STAFF REPORT

To: University Heights Zoning
Commission

Date: July 28, 2017 *[Revised 12/20/17]*

This report was created by the Metropolitan Planning Organization of Johnson County (MPOJC) planning Staff at the request of the City of University Heights. This report is intended to provide general guidance to the City during review of the Planned Unit Development (PUD) submittal (dated June 4, 2017) for 901 Melrose Avenue.¹

Figure 1: Concept Plan with building reorientation

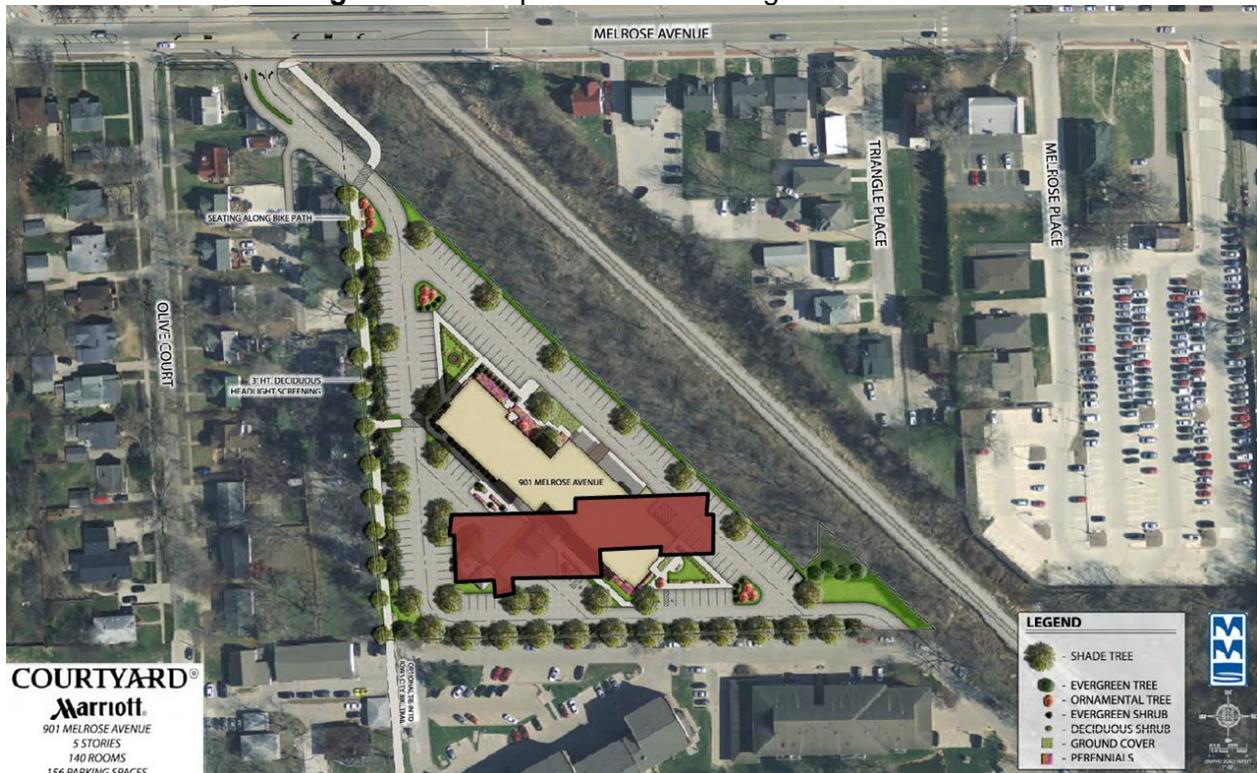
The proposed building is situated to the south side of the property, oriented parallel with the east property line, with the hotel entrance facing single-family residential properties to the west. This orientation may create unnecessary negative externalities, such as noise and light, for the single-family residences on Olive Court. The City and the applicant should discuss reorienting the building so that the back of the hotel is facing the medium-density apartments to the south and the front is facing Melrose Avenue. The proposed use of the property is similar to the medium-density apartments to the south in that it has a comparable physical characteristic (multiple-story building, large parking lot, etc.). Reorienting the hotel in this way would improve the presentation of the entrance and may reduce some of the negative externalities associated with a hotel entrance experienced by the single-family residences to the west. For reference, Staff reoriented the building to scale on the concept plan as shown in **Figure 1**. With this configuration, a continuous access along the eastern property line would not be available and the site layout (landscaping, parking stalls, etc.) would need to be reconfigured. *[The building orientation was discussed at previous City Council meetings and a change in building configuration was not desired by the developers.]*

Figure 3: Manual on Uniform Traffic Control Devices Figure 4C-3

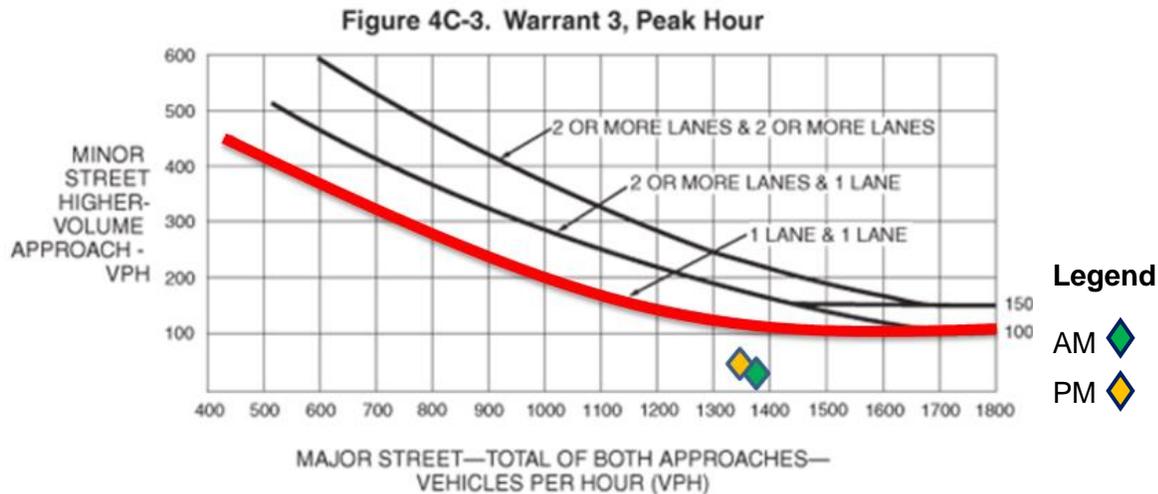
Traffic Signal Analysis: A planning-level traffic signal warrant analysis was completed for peak hour traffic and shows that a traffic signal at the proposed entrance to the development is not warranted (**Figure 3**). To meet the peak hour warrant, it was determined that an additional 90 vehicles would need to exit the development during the AM Peak and an additional 81 vehicles would need to exit during the PM Peak hour to satisfy the requirements for traffic signal installation. Current estimates only project a total of 30 and 39 vehicles exiting the development during peak travel hours. *[No change.]*
